Access Compliance Report

Public Rights-of-Way

Intersection ID: 14139	Main Street: S_TRYON_ST	Cross Street: W_TREMONT_AV	Location: SW
ADA ID: E05C1122D23F	Ramp Type: Perp	Initial Pass/Fail: Fail	Overall Compliance: No
		Severity Score: 8.75

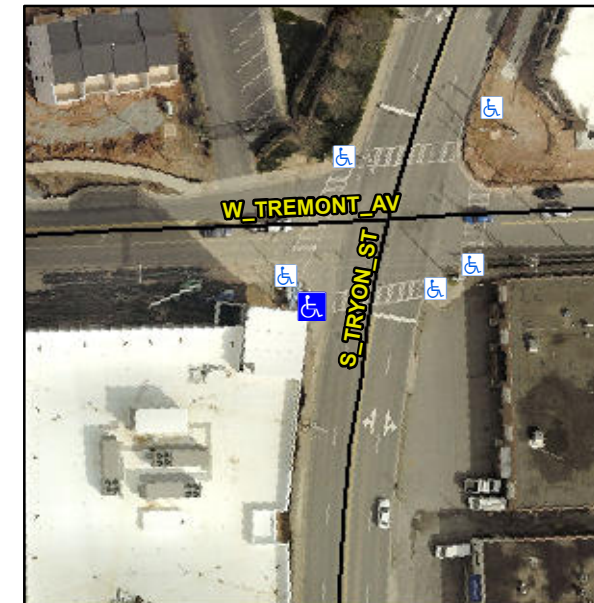
Not Found, R304.5.1

Compliance	Description	Data	Compliance	Description	Data
N/A	Ramp Length (in)	76.0	Yes	Ramp Slope (%)	6.2
No	Ramp Width (in)	43.0	Yes	Ramp XSlope (%)	0.1
N/A	Flare Type LT	N/A	N/A	Flare Type RT	N/A
N/A	Flare Slope LT (%)	N/A	N/A	Flare Slope RT (%)	N/A
N/A	Flare Traversable LT?	N/A	N/A	Flare Traversable RT?	N/A
N/A	Landing Length (in)	N/A	N/A	DWS Provided?	N/A
N/A	Landing Width (in)	N/A	N/A	DWS Contrast?	N/A
N/A	Landing Slope (%)	N/A	N/A	DWS Length (in)	N/A
N/A	Landing X Slope (%)	N/A	N/A	DWS Full Width?	N/A
N/A	Landing Curb? (Y/N)	N/A	N/A	DWS Offset (in)	N/A
N/A	Shared Landing?	N/A			
N/A	Gutter Ponding?	N/A	N/A	Gutter Slope (%)	N/A
N/A	Gutter Lip Ht (in)	N/A	N/A	Gutter X Slope (%)	N/A
N/A	Painted X Walk1?	Yes	N/A	Painted X Walk2?	N/A
	X Walk 1 Direction	To E		X Walk 2 Direction	N/A
N/A	X Walk 1 Width (in)	104.0	N/A	X Walk 2 Width (in)	N/A
	X Walk 1 Slope (%)	2.8		X Walk 2 Slope (%)	N/A
	X Walk 1 X Slope (%)	1.9		X Walk 2 X Slope (%)	N/A

Remove & Replace Entire Ramp.
